SITE: TYPE: DESCRIPTION:	Land adjacent to Delmere, Upper Hill Planning Permission Erection of detached dwelling house within the curtilage of the existing dwelling and erection of a detached garage for the existing dwelling
APPLICATION NO:	201538
GRID REFERENCE:	OS 347015, 253093
APPLICANT:	Mr T Stephens
AGENT:	Mr DF Baume

Overview of the Proposal

Figure 1: Environment Agency Flood Map for Planning (Rivers and Sea), June 2021

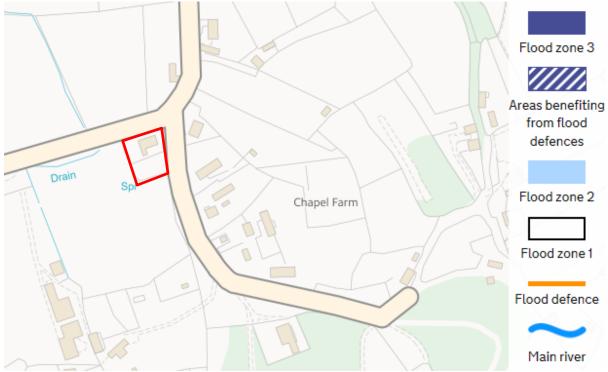
Review of the Environment Agency's Flood Map for Planning (Figure 1) indicates that the site is located within the low risk Flood Zone 1.
